UNITED STATES DISTRICT COURT
FOR THE DISTRICT OF MASSACHUSETTS

Civil Action Nos.
99-30225, 99-30226,
and 99-30227-MAP
(consolidated)

FOURTH MODIFICATION OF CONSENT DECREE

WHEREAS, this Fourth Modification changes the Decree in two respects: (i) it slightly expands the maximum horizontal extent of the acreage of the Hill 78 On-Plant Consolidation Area ("Hill 78 OPCA"), without changing the elevation or capacity of that OPCA, and (ii) it clarifies that crushed building debris from buildings formerly located within the 40s Complex at the GE Plant Area may be used, under certain conditions, at certain properties that GE has or will transfer to PEDDA, in lieu of materials originating from an off-site location, with EPA written

FIGURE
E-1

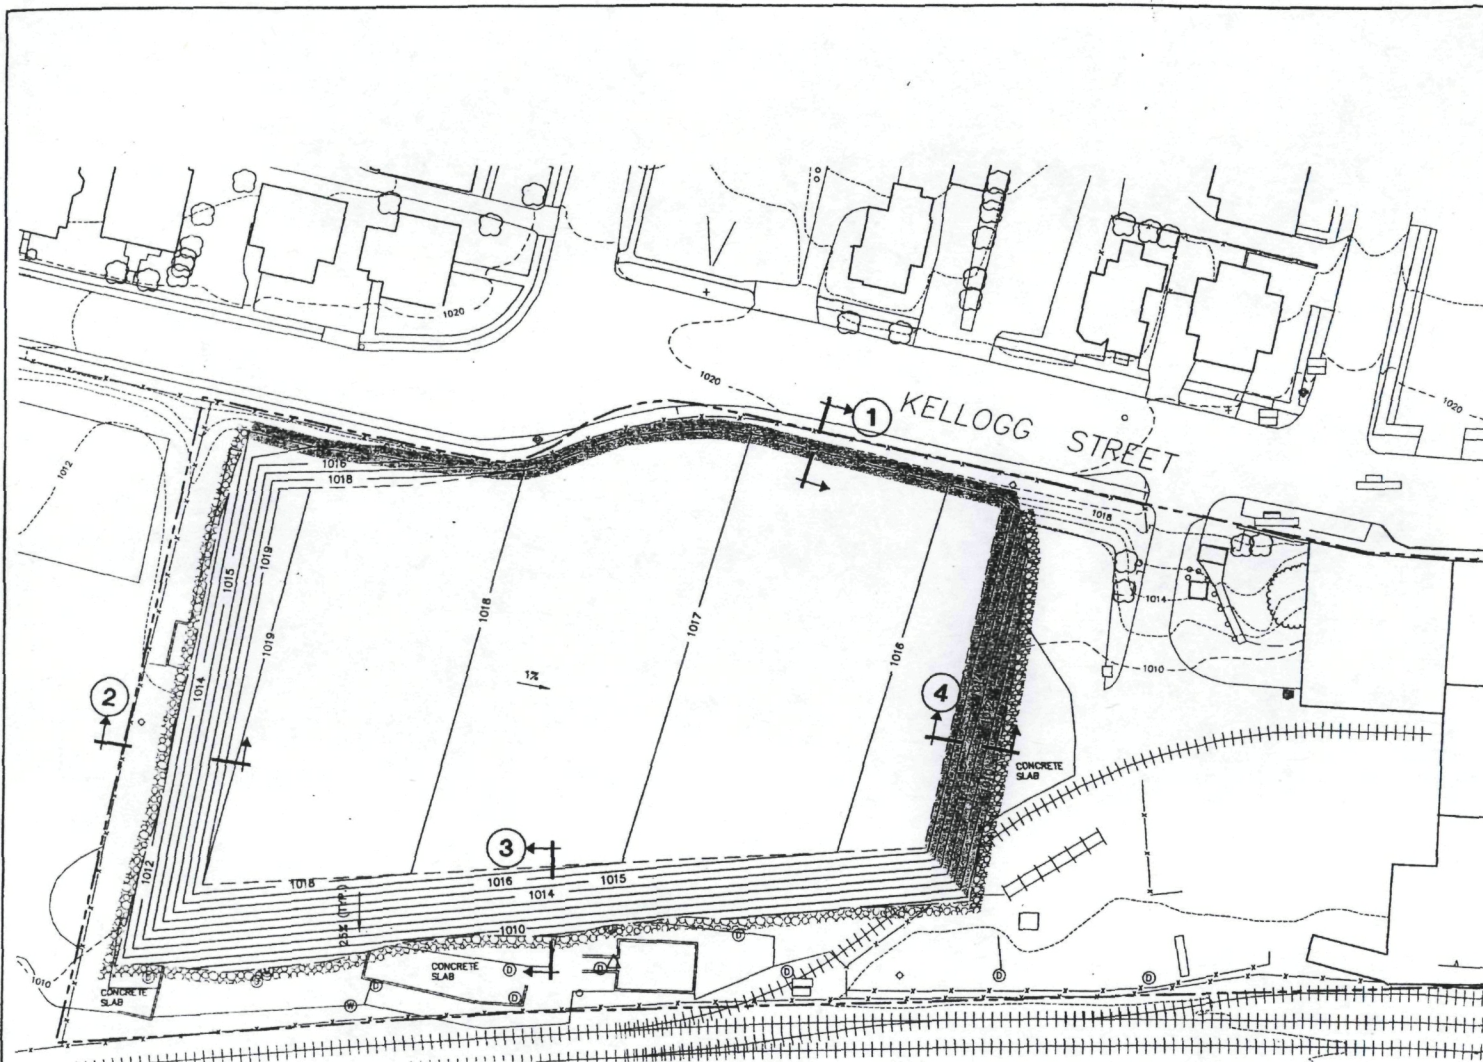
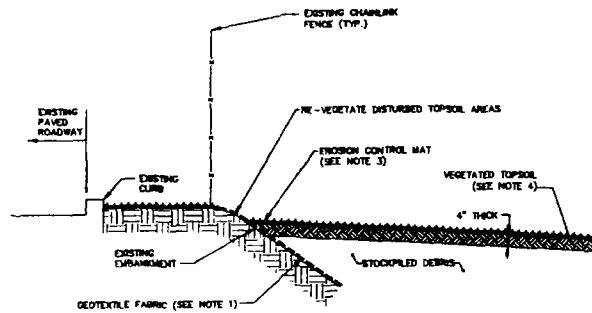
- The limits of the stockpile have been identified on Figure E-1. Those limits are the maximum "build-out" limits and may be lessened (in vertical and/or horizontal directions) based upon the actual amount of material subject to placement in the stockpile.

- As shown on Figures E-1 and E-2, the northern edge of the stockpile will be tapered into the existing grade along Kellogg Street with a proposed maximum elevation of approximately 1,019 feet above mean sea-level (amsl). The proposed elevations shown on Figure E-1 also include a 4-inch thick layer of topsoil that will be seeded with a grass seed mix. In addition to these features, an erosion control mat will also be installed along the northern edge and eastern slope of the stockpile to minimize erosion/formation of gullies as a result of runoff from storm events.

- Figures E-1 and E-2 also depict that the maximum slope along the eastern, southern and western sides of the proposed stockpile will be 25% (4 horizontal to 1 vertical) and the top of the proposed stockpile will be graded at approximately 1% sloping downward in an easterly direction. This grading scheme is designed to minimize erosion and transport of the stockpiled materials as well as to maintain drainage in the 40s Complex RAA. Other erosion control methods include the installation of rip-rap along the eastern edge and 2-inch stone along the southern and western edges of the toe-of-slope to dissipate storm water runoff from the stockpile (Figure E-2).

FIGURE
E-2

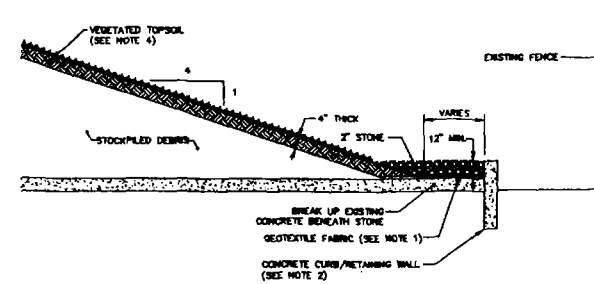
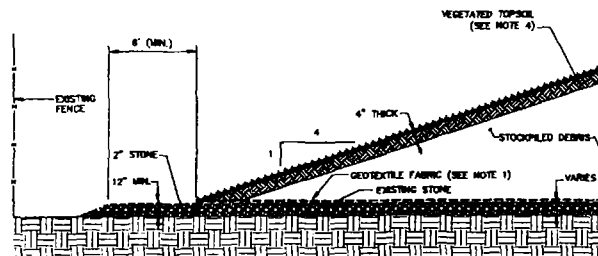
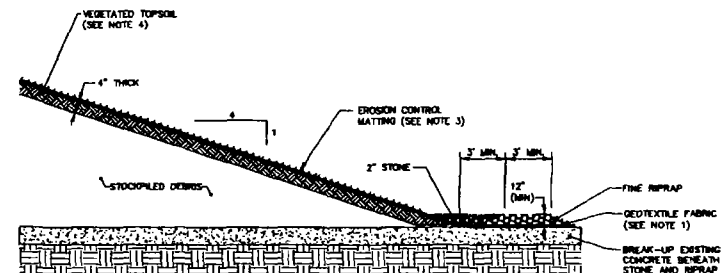
2. WHERE CONCRETE CURB/RETAINING WALL IS NOT PRESENT, USE STONE CONDITION SHOWN IN SECTION 2.
3. EROSION CONTROL MAT SHALL BE NORTH AMERICAN GREEN S150 OR EQUAL AND INSTALLED PER MANUFACTURE'S SPECIFICATIONS.
